Comal County Environmental Health OSSF Inspection Sheet

Permit of Authorization to Construct an On-Site Sewage Facility Permit Valid For One Year From Date Issued

Permit Number: 115944
Issued This Date: 03/30/2023
This permit is hereby given to: Jose Fidel Anaya

1410 CYPRESS GARDENS BLVD
SPRING BRANCH, TX 78070

OWNER: JOSE FIDEL ANAYA
LEGAL DESCRIPTION: LOT 1, BLOCK 114, CYPRESS LAKE GARDENS, HIGH COUNTRY SECTION
ADDRESS: 1410 CYPRESS GARDENS BLVD. SPRING BRANCH TX 78070
PREPARED BY: THALIA RIVAS RS 5067 SCALE: 1" = 30'

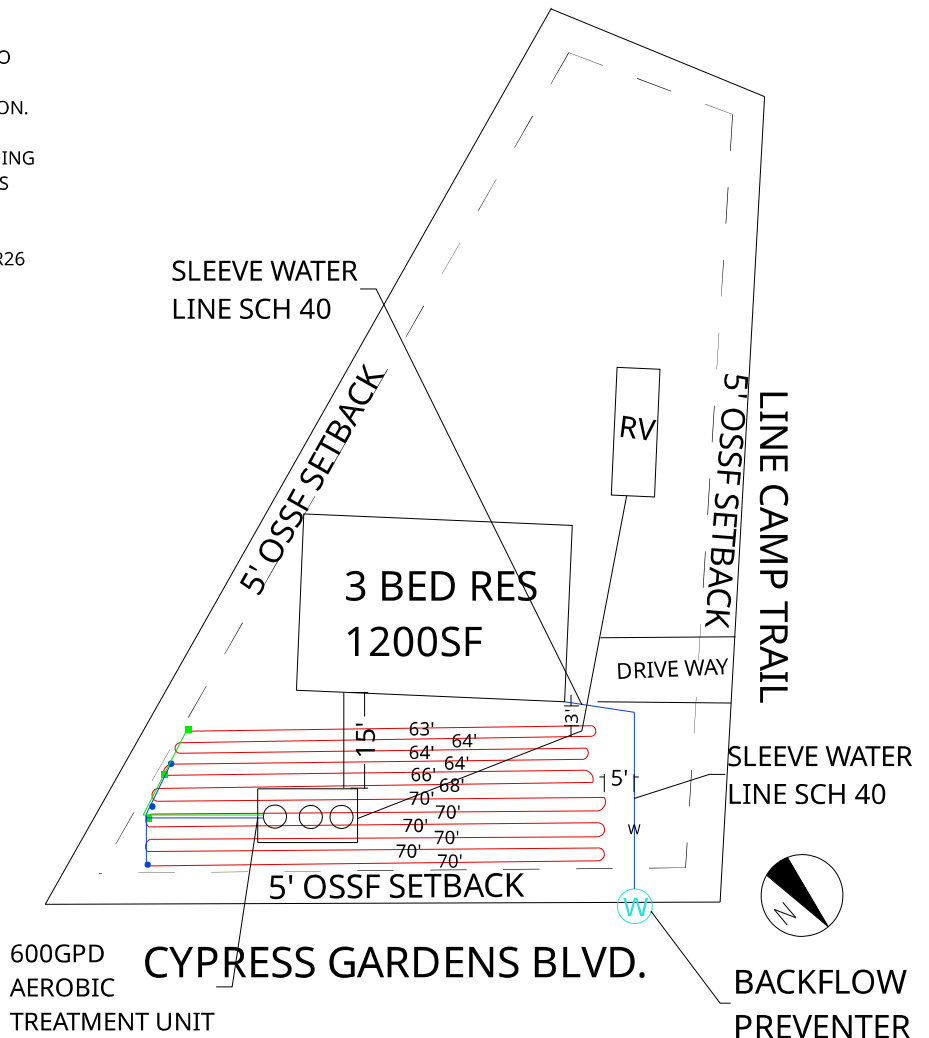
3/26/25 EG: Waterline sleeved. Tight line halfway between rv and tank does not have adequate fall. Clean out is needed between rv going towards tank.

3/28/25 EG: Tight line has appropriate fall, clean out has been added. Covered.
